APPEAL SUMMARY

Appeal ID: 27590	Project Address: 4234 SE Henderson St
Hearing Date: 3/16/22	Appellant Name: Courtney Giordano
Case No.: P-001	Appellant Phone: 5035440617
Appeal Type: Plumbing	Plans Examiner/Inspector: Dawn Krantz, McKenzie James, Jim Bechtel, Joe Blanco
Project Type: residential	Stories: 2 Occupancy: owner Construction Type: wood frame
Building/Business Name:	Fire Sprinklers: No
Appeal Involves: Alteration of an existing structure	LUR or Permit Application No.:
Plan Submitted Option: pdf [File 1]	Proposed use: Residential

Appeal item 1

BASEMENT BATH - PROPOSED NEW

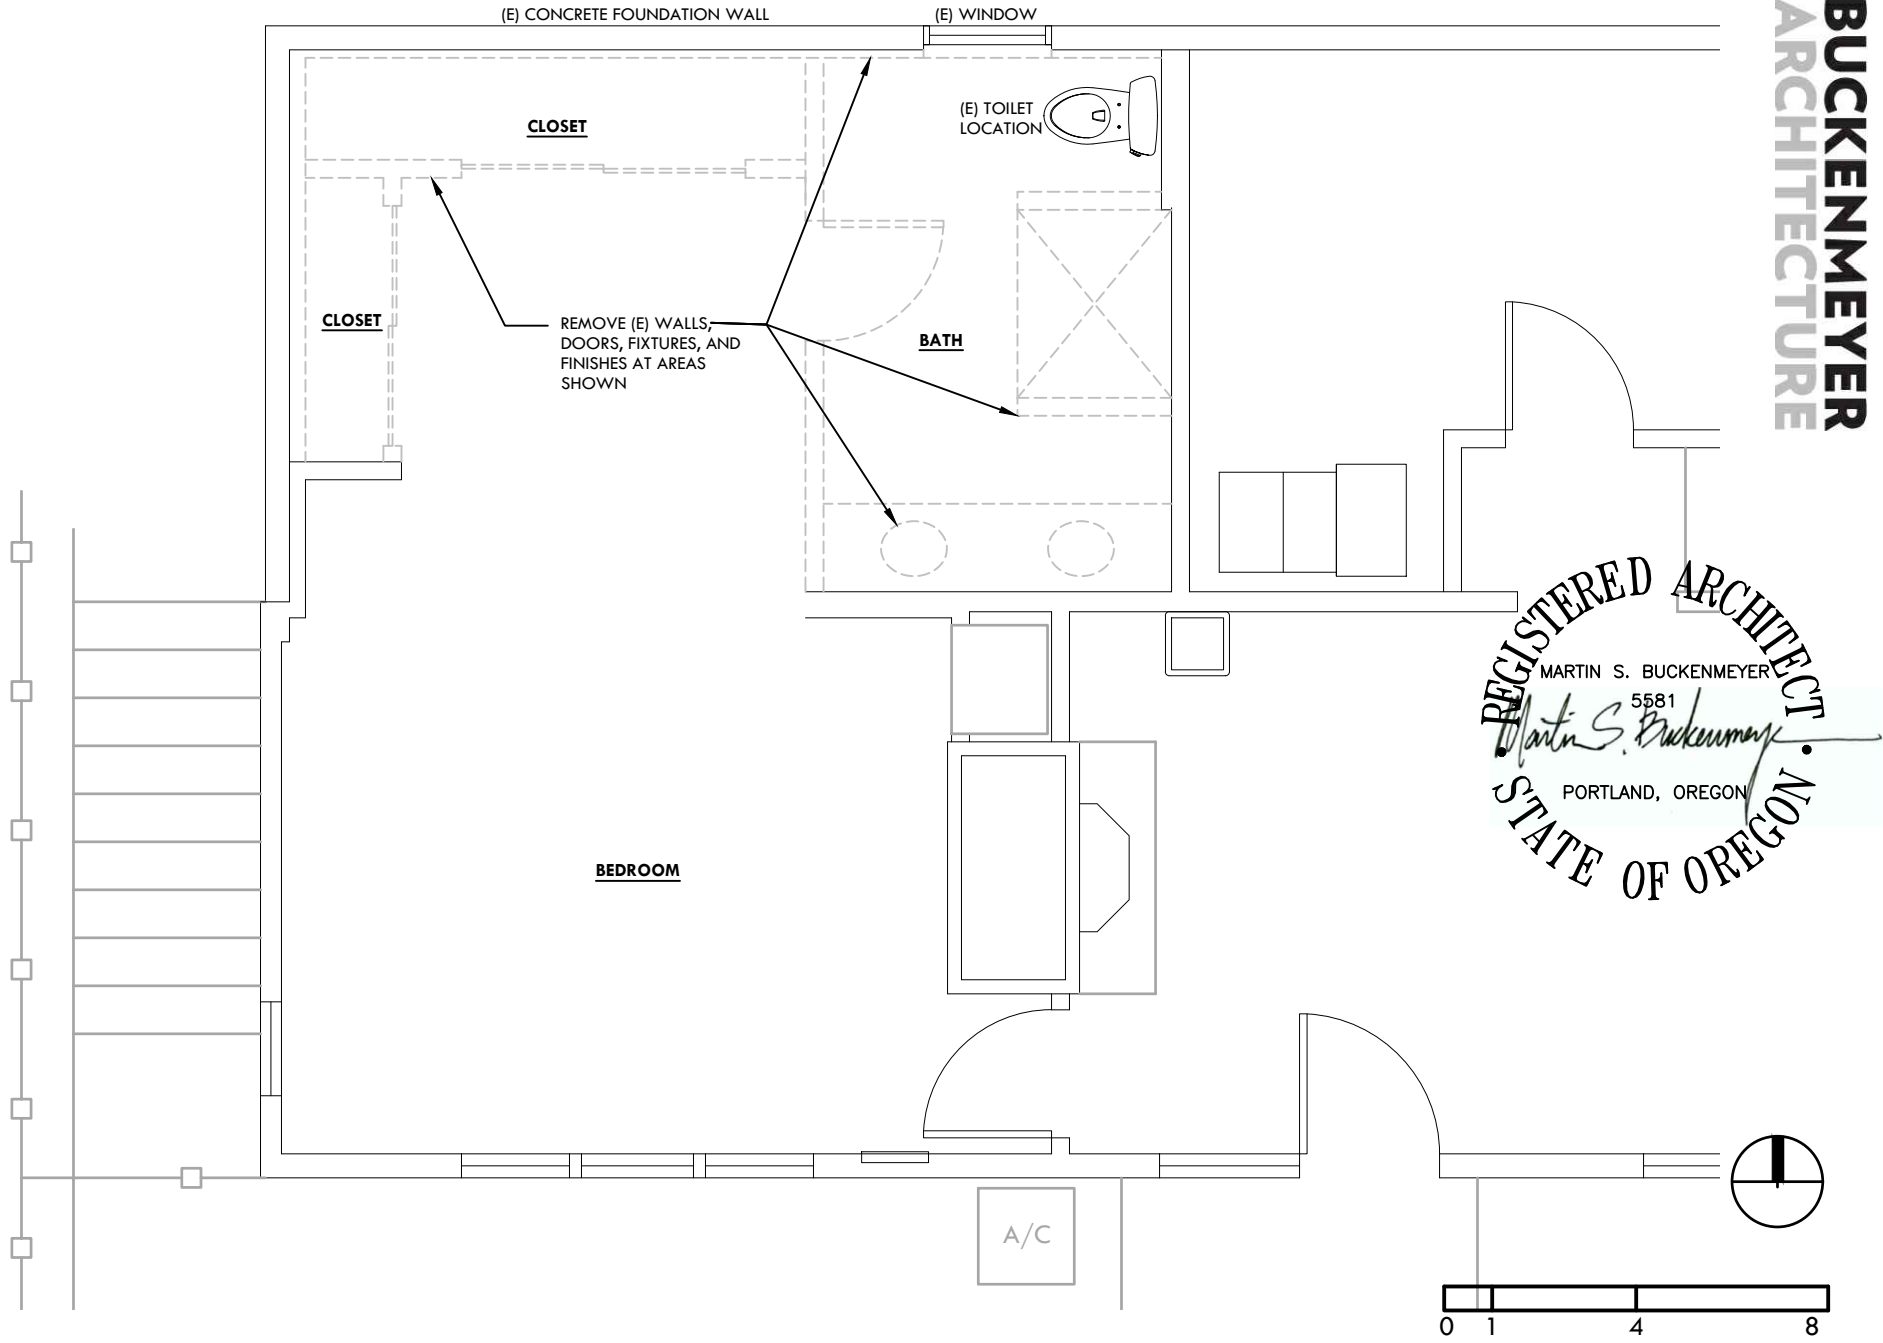
Code Section	402.5 of the 2021 Oregon Plumbing Specialty Code
Requires	No water closet or bidet shall be set closer than 15 inches from its center to any side wall or obstruction.
Code Modification or Alternate Requested	Allow to maintain the current historic distance of 14" from the north bathroom side wall to water closet center after restoring water damaged drywall following waterproofing the interior foundation wall.
Proposed Design	We would like to propose that an exception be made to the 15" clearance requirement between the toilet drain and the north side wall. If the small portion of the wall undergoing the waterproofing that is adjacent to the toilet can once again be flat-framed, the distance between the wall and the toilet drain will be a comparable distance to what it has historically been (approximately 14") without tampering with the existing cast iron in the foundation of the house. Please see the provided drawing where the details of the current finished and heated bathroom, closet, bedroom in their existing layout are on page 1 and the proposed changes are detailed on page 2. In total, 25'9" of existing flat-framed and uninsulated exterior walls will be demoed to add waterproofing. 18'7" will be restored using conventional framing and will add R-15 insulation and air space where currently none exists. The remaining 7'2" would be flat-framed to allow for air space and minimum R-6 insulation as possible to be added after the completion of the waterproofing and to maintain 14" clearance from wall to toilet center.

WALL ASSEMBLY:
-(E) CONCRETE WALL
-1/2" DRAINAGE AREA
-2X4 P.T. WOOD STUDS
-R-15 KRAFT-FACED BATT
INSULATION BETWEEN STUDS
-1/2" GWB

WALL ASSEMBLY:
-(E) CONCRETE WALL
-1/2" DRAINAGE AREA
-FLAT FRAMED 2X4 P.T. WOOD STUDS
-R-6 (MIN.) RIGID BOARD INSULATION
BETWEEN STUDS
-1/2" GWB

Reduction in the minimum required side wall clearance of water closet from 15 inches to 14 inches: Granted as proposed.

BASEMENT BATH - DEMO

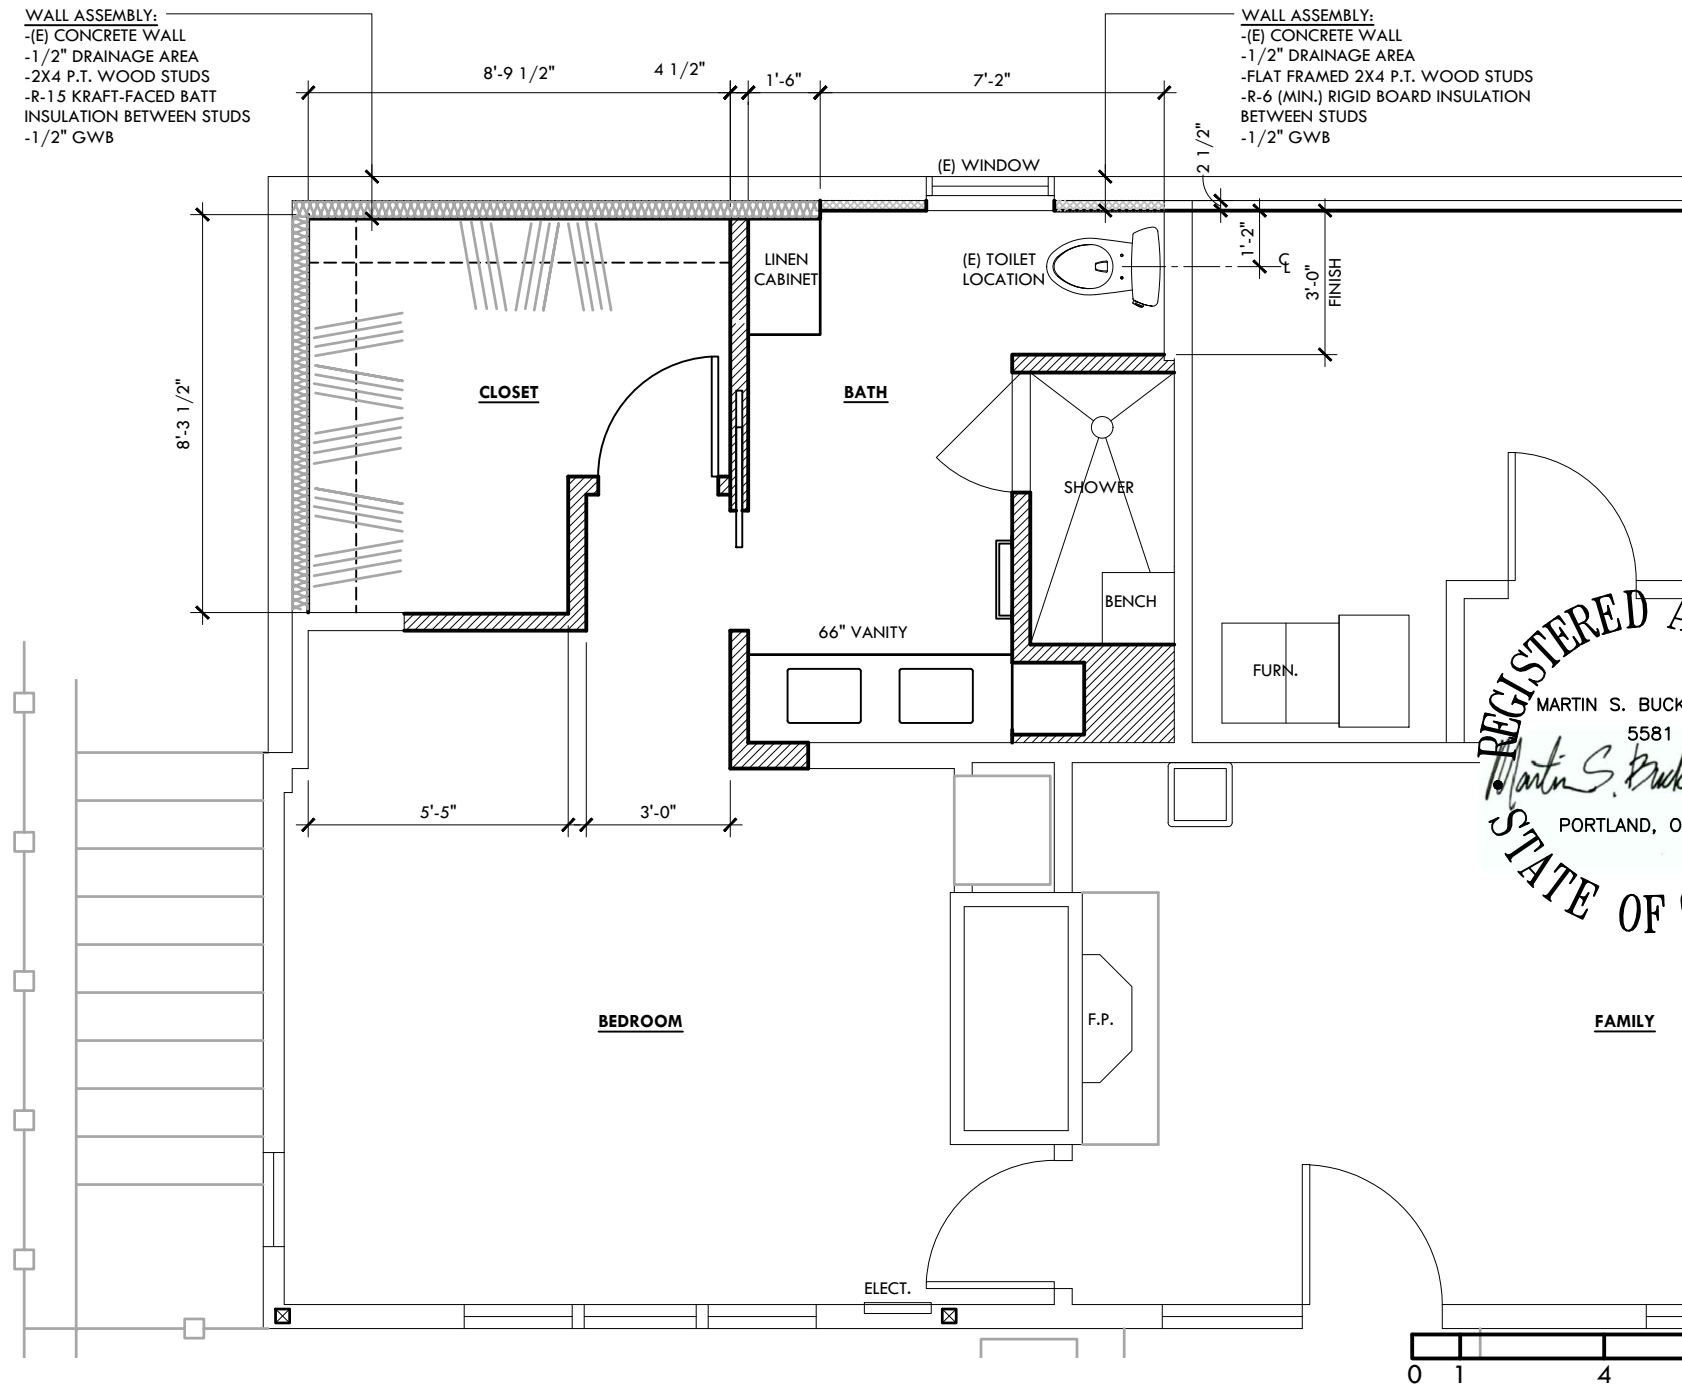
To restore the bathroom wall with the waterproofing in place, the clearance to the center of the toilet drain will not be able to meet the 15" requirement without excavation of the existing cast-iron waste drain. To move the existing drain would incur cost-prohibitive expenses and would require demolition of exterior front steps, a 50+ year old rhododendron, the new concrete walkway and extensive front yard landscaping that we put in after replacing our sewer line in 2016.
